SAFETY ALERTS

#0010

Potential risk of rudder pedal getting caught on a button head

screw of the centre console when rudder is fully deflected.

DIAGRAM(S):

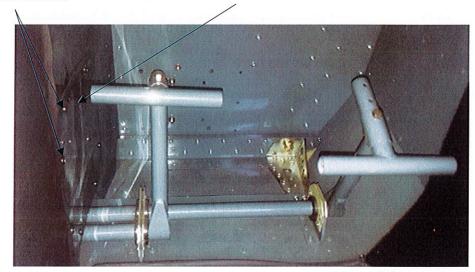
The Safety Alert provides the instructions for the rectification of rudder pedal T-pieces. This modification will prevent the rudder pedal T-piece from getting caught on a button head screw of the inspection panel cover (located on the centre console used to access the rudder stops) at full rudder deflection. The two modified T-pieces should be installed on the right pedal of the pilot side and the left pedal of the passenger side.

- 2. Measure and mark 5 mm from along each end of the rudder pedal T-piece.
- 3. In a vice grip or otherwise, cut and deburr the marked ends.
- 4. Return the rudder pedal T-piece into the rudder pedal, install the bolt and tighten with the new AN3 nyloc nuts.
- 5. Ensure the new clearance, after installation, between the ends of the rudder pedal T-piece and screws of the inspection panel cover exceeds 3mm.
